DWG Procedure Manual: ERCOT Response to Comments

Sun Wook Kang
Dynamic Studies, ERCOT

IBRWG/DWG Joint Workshop
August 9, 2024

- A high-level generation interconnection process for a new IBR project

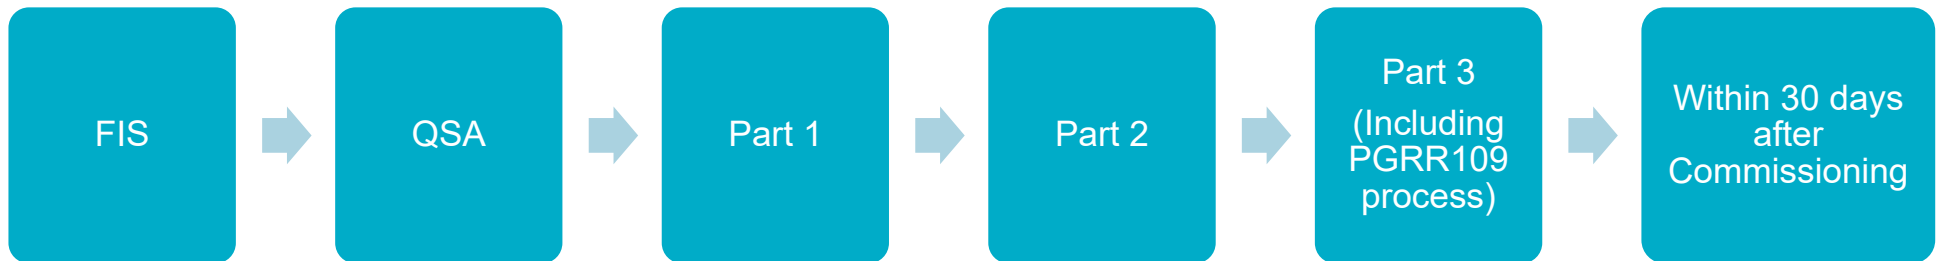
- ❑ Comment #2: Making the effective date for new modeling elements at least concurrent with the ride-through capability maximization deadline for IBRs proposed in NOGRR245
- ❑ Comment #6: Question about the timing of implementation of these requirements and at what stage of the interconnection process
- ❑ ERCOT Response:
 - DWG manual is designed to provide technical description. The process and timing to submit model quality tests are already defined in the Planning Guide Sections 5 and 6. Deadlines or Extension process to meet the ride through requirements are defined in NOGRR245
 - For example, if an existing operational IBR plans to change control settings to maximize its capability, it must go through the [PGRR109](#) process (see [PG5.5 \(5\)](#)) prior to implementation in the field

- For example, a new IBR project going through the generation interconnection process, IE/RE must submit model quality tests for FIS, QSA, prior to commissioning, and after commissioning. See [PG Sections 5 and 6](#)
- If new ride through test(s) are not conducted or found to be deficient, the IE/RE must provide an explanation, along with the execution date of the Standard Generation Interconnection Agreement (SGIA) and synchronization date
- Deadlines and extension processes for meeting the ride through requirements are already defined in [NOGRR245](#)
- It is IE/RE's responsibility to consider deadline and follow the rules in the ERCOT binding documents

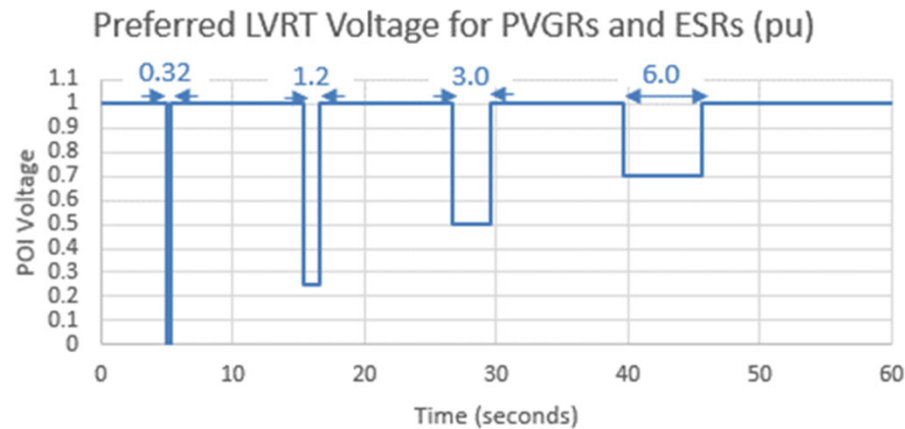
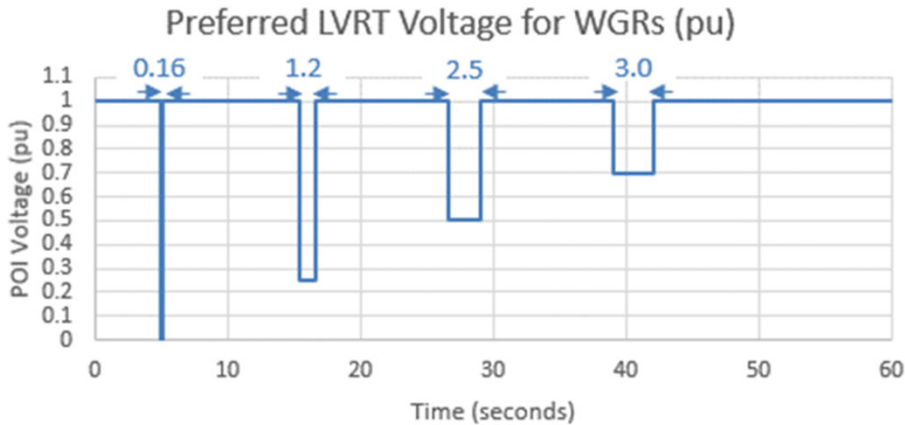
- ❑ Comment #3: Suggestion that new facilities perform tests using the preferred curve, while existing facilities perform tests using the legacy curve with the option to test against the preferred curve depending on site maximization

- ❑ ERCOT Response:
 - **HVRT:** If it passes the preferred HVRT curve test, testing the legacy curve is unnecessary because the legacy curve is subset of the preferred HVRT curve

- **LVRT:** Testing both preferred and legacy LVRT curves are necessary.
 - For existing units (e.g., unit going through PGRR109 process), the legacy curve test helps verify compliance with legacy ride through requirements. The preferred curve test (a.k.a., voltage dip test) helps confirm functions like active power injection during voltage dips (e.g., 0.7pu) and possibly demonstrate their capability beyond legacy curve

- For planned units, the legacy curve test helps demonstrate the performance of the voltage recovery ramp that lies within the preferred ride through requirements in NOGRR245 and confirm proper reactive control behavior during the voltage recovery ramp. The voltage dip test ensures compliance with the preferred ride through requirements

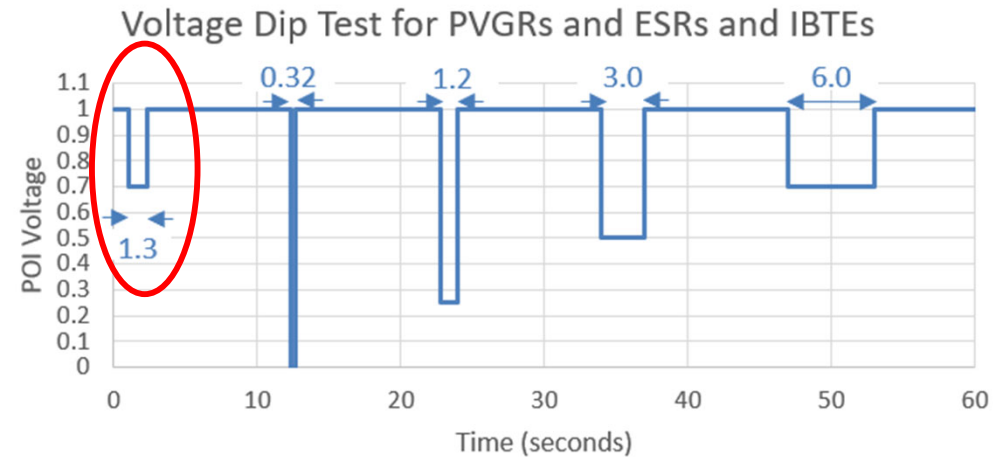
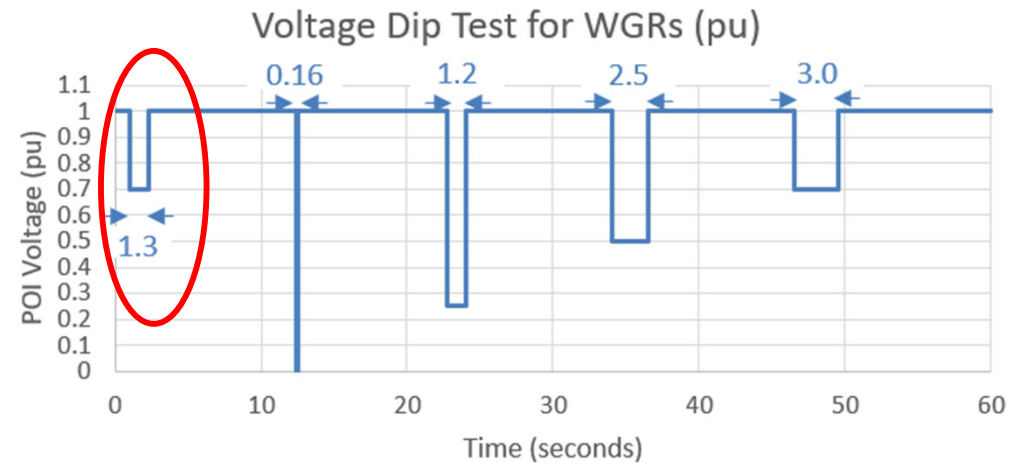
- Since the last IBRWG/DWG joint workshop, ERCOT has made a minor modification to the “voltage dip test” profile to enhance effectiveness of testing existing unit. This addition addresses feedback received based on operational experiences
 - Added voltage dip and duration → 0.7 p.u. for 1.3 second
 - The shorter duration (1.3s) is a value calculated to be within the legacy ride through curve (see Table A in NOGRR245 Section 2.9.1.2)
- ERCOT has updated the DWG manual to rename the preferred LVRT curve as the “**voltage dip test**” and updated the corresponding figure (see the next slide)

Existing facilities only required to ride through the first dip
